TO: Mercedes-Benz Dealer Principals, General Managers, Sales Managers, Service Managers, Parts Managers	FROM: Thomas Brunner, Department Manager, Vehicle Compliance and Analysis, Engineering Services
RE: Recall Campaign 2016100001 Model 213 (E-Class) MY 2017 Reroute Fuel Pump Control Unit Harness	DATE: October 19, 2016

SUBJECT: **Model 213, Model Year 2017**
Re-route Fuel Pump Control Module Harness

Order No. P-RC-2016100001

Figure 1

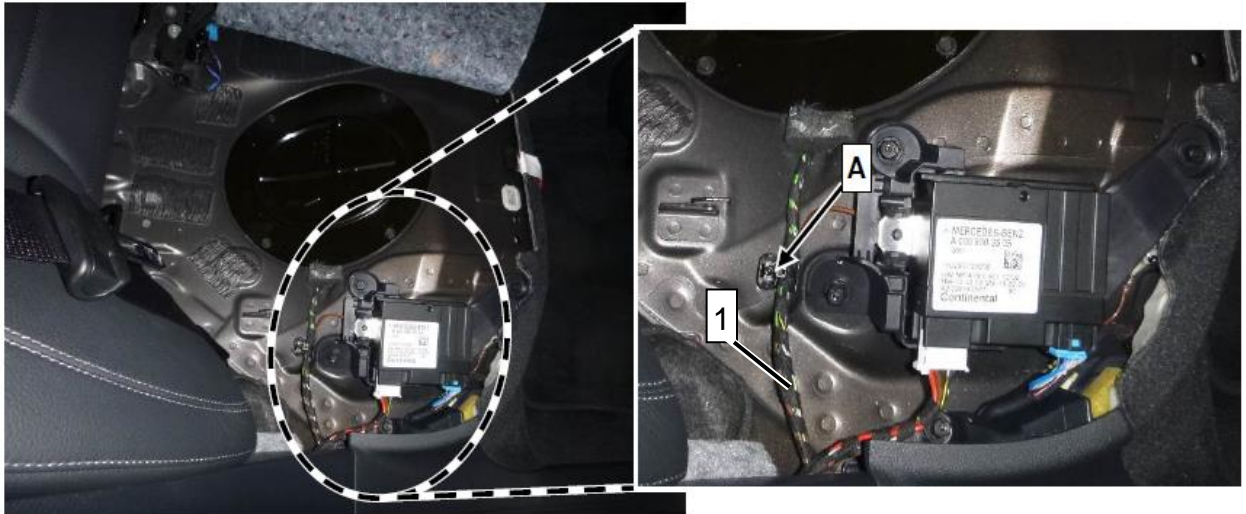
1. Remove rear seat cushion, refer to WIS: AR91.12-P-1020LW.
i **Note:** The rear seat cushion does not need to be completely removed. It can be moved to one side with wiring harness connected (for models with code 872 heated rear seats).
2. Remove cable tie (A, Figure 1).
i **Note:** Cable tie is no longer needed.

Figure 3

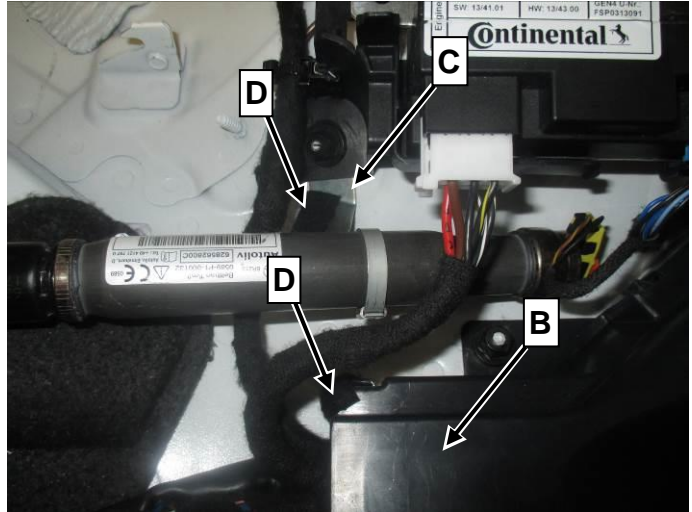
4. Cover edge of cable duct (B, Figure 3) and mounting bracket (C [if equipped]) with felt tape (D) to prevent wire chafing.

Figure 4

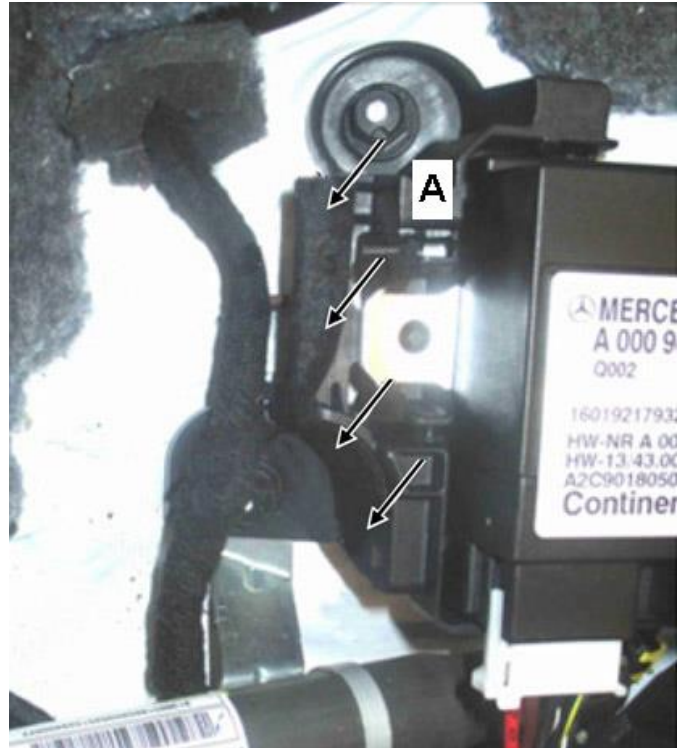
5. Cover edge of fuel pump control module mounting bracket (A, Figure 4) with felt tape (arrows).
